Burgess Park Southern Entrance Project, Initial Consultation 2014/2015

Burgess Park 'Southern Entrance' Project

5.2. Area A: Rust Square

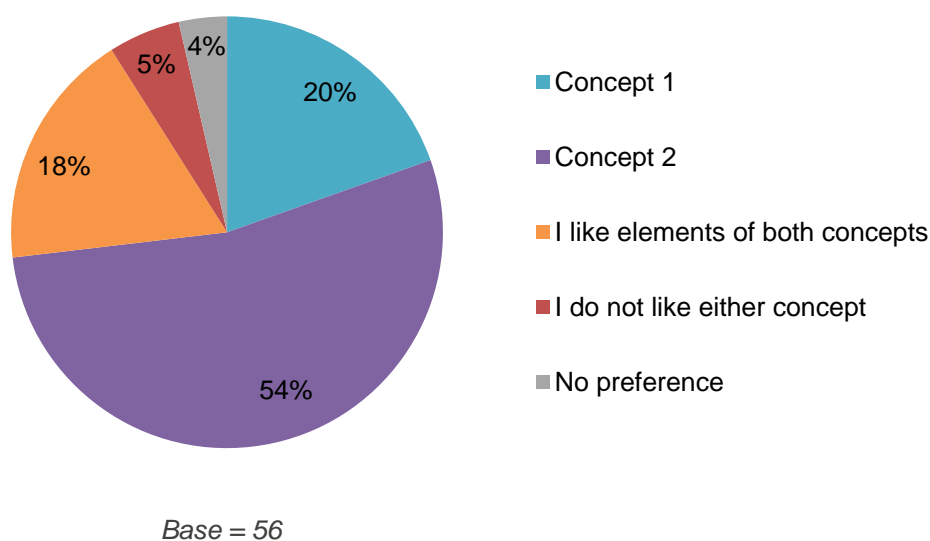
“The existing area feels really dated and uninviting. What you have done with the rest of the park is so successful it would be better to integrate Rust Sq into the feel of the rest of the emerging park”

“I like the way the square is integrated into the park in concept 2”

“Creating a more integrated and connected space with a water feature would be lovely. Refurbishing the bricks in certain areas would look nicer than replacing them with the metal arches and skew railings put up in other areas of the park which will probably start to look quite dated in the near future.”

“Are[a] is very dark and parts are uninviting and in the evening feel unsafe at present.”

“The charm of Rust Square and the adjoining green space is that they are ideal for quiet reflection and are off the main thoroughfare of the park.... A far more interesting way to use this space would be to incorporate a sculpture court and changing installation art and maintain the meditative atmosphere and respite it presently provides ... besides the whole park has very little by way of art in a neighbourhood full of artists!”

“For Rust Square I question the value of a water feature in terms of capital cost as well as future maintenance liabilities. As budgets are tight I would favour a refurbishment of the existing paving and expending more money on a well designed and exciting children's play area in the vicinity of the location suggested in Option 2”

“Play area should not be here. Too close to residents living in Kitson Road and Rust Square.”

“You must consider noise for the residents who are very close to this area. There is a huge park - please site the play area further from the homes. Teenagers congregate at night, shouting into the small hours.”

“I like the fountains in Concept 1”

“No water feature, Burgess Park does not have a good track record of keeping water features going. Don't add raised planters.[T]he brick steps look better. This square has a French feel, why not add a boulevards pitch on the raised grass area?”

5.3. Area B: the area adjacent to Rust Square

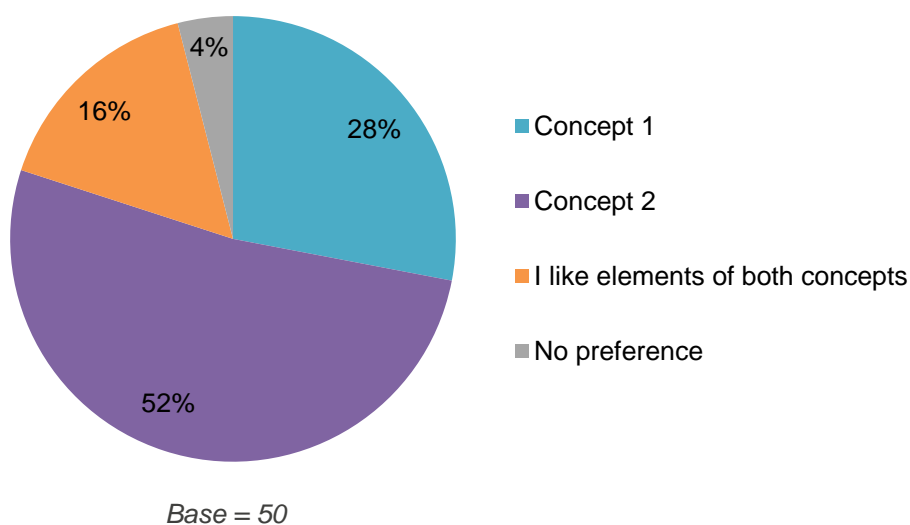
“Would be nice to reconnect rust square with the rest of the park, but the long straight paths are only good for cyclists. As a pedestrian the park is now less attractive to walk through as the long straight paths are quite dull - all you see ahead of you is more grey path and you're always having to watch out for cyclists going at great speeds.”

“Straight paths are for cyclists not pedestrians - pedestrians spend more total time in the park and more should be done to make their journey and experience through the park interesting and enjoyable rather than feeling like you're on a long straight tred-mill!”

“A more gently curving path rather than straight as it encourages cyclists to speed.”

"No picnic tables or planting required.. this is a nice, quiet, uncluttered space to spread out a picnic blanket. Perhaps some natural willow teepees or rope swings from the trees would be interesting. A clear link to the wider park is not attractive as it would lay the space wide open and ruin the quiet charm and character of the pocket park."

No picnic area or play area. Already a problem with people gathering and making noise in Rust Square.

"Concept 1 would be a disaster. Every weekend during the summer of 2014 large groups (20-50 people at a time) gathered for day-long drinking and BBQ sessions with heavily amplified music. They brought trolleys loaded with car batteries to power the noise. Every weekend. Till at least 10 at night. It was a nightmare for residents and "picnic tables" would legitimise this severely anti-social behaviour. Please site such facilities deep in the large park where they won't disturb residents so much."

"I like concept 2 but think it should include play equipment further away from Kitson Road because of noise."

5.4. Area C: the central open space

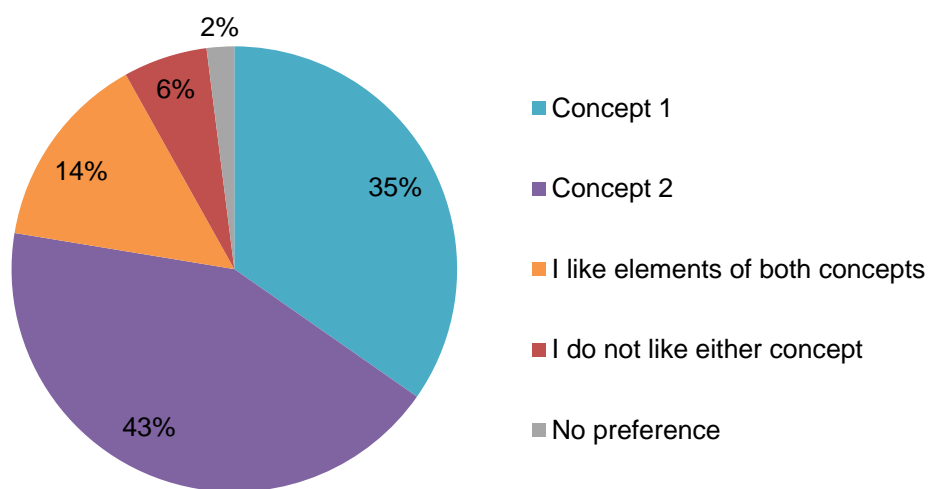
“I prefer Plan 1 because it has fewer added paths of which there are too many in Plan 2”

“I like: fewer paths, espec. in so-called Wildlife area- if we are to have wildlife, people should NOT be encouraged into the wildlife area. I do NOT like addition of large numbers of paths.”

“Simple and shared path/ cycle links are preferred. The sitting open spaces should be respected and not subdivided by more paths.”

"Please keep the shared areas for pedestrians and cyclists. We have to be aware of each other and respect each person's desired mode of travel. Creating separate areas will be difficult to enforce and encourage greater speed of cycling - as a parent with young kids I worry they will be exposed to faster, less observant cyclists. "

"Cyclist and pedestrian movement to be segregated entirely with low level hedges/planting as dividers when the paths run parallel. This means children and animals can run and play safely... cyclists will also be happy as they can make time! This is a glaring design oversight that ought not be fixed with makeshift solutions. We now have a clear picture of the nature of the different types of users of the park and a thoroughfare must be recognized and treated as one."

"Mains routes should NOT be shared by cyclists and pedestrians. This does not work. This should be pedestrian only. Cyclists regularly intimidate pedestrians in this area."

"I like from Concept 2 - the avenue of trees and the greater amount of planting."

5.5. Area D: the nature area

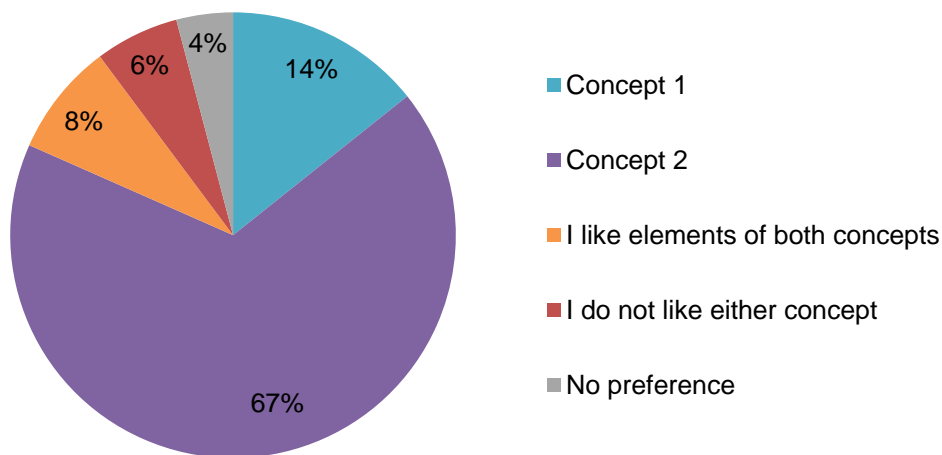
“I like from Concept 2 - the avenue of trees, the lake and the greater amount of planting.”

“[N]ice to create a more natural and sheltered lake area - the other lake is very big and open and not very interesting to explore as you can see everything when you get to the area.”

"There is only a small pond in concept 1 which is appropriate for the wildlife area. Another lake is unnecessary and too big for the general area."

"A lake is out of keeping with the smaller area of this part of the park- a pond is more appropriate. But I like the idea of removing New Church Rd and would make as few new pathways as possible. Planting more native trees would be a good idea."

"Pathways through the nature area will make this area less attractive to wild life than it is. A lake is too big for this area - a pond would be much better. Avenues with straight lines of trees are unattractive and too stiff and formal."

"I love the lake and I love the wildflower meadow! Just get rid of New Church Rd! I feel that the pedestrian crossing on Wells Way needs to be designed to a reduce carriageway width in that area (but not to the detriment of cycle safety) to change the feel of the space for vehicle drivers. I would also like to see the space designed to ensure maximum speeds throughout the length of Wells Way"
